Reduced inrush current after removing 10uF on REG_CAP pins.

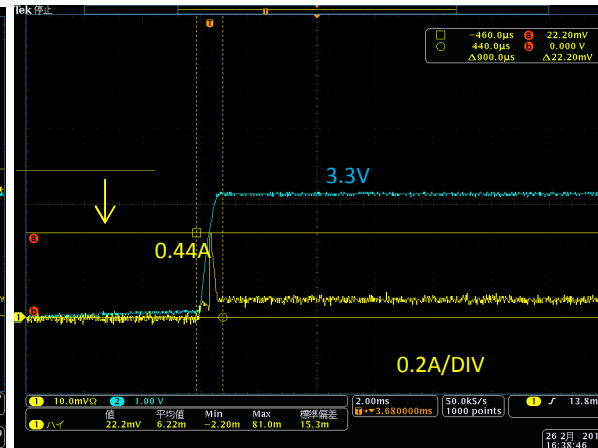
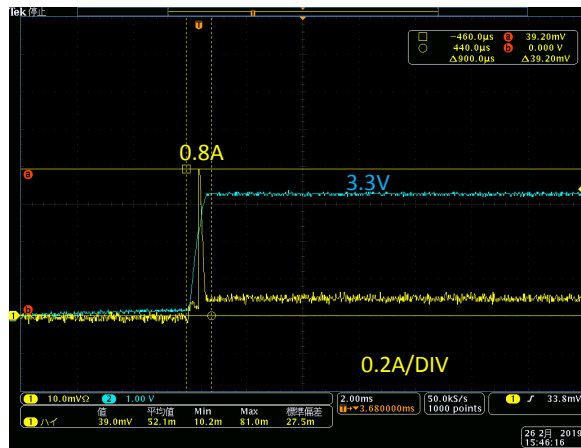
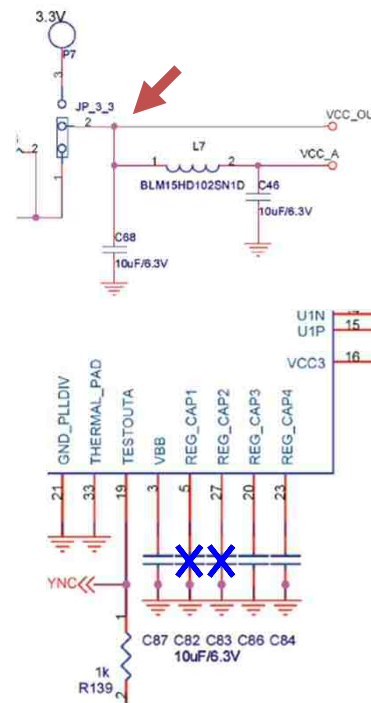
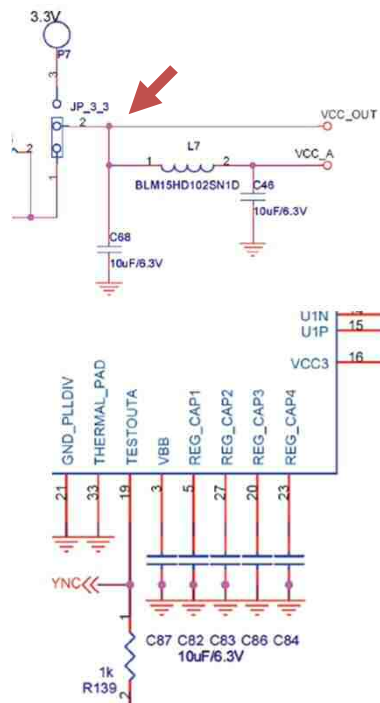
Removed 10uFx2 on REG_CAP 1/2.
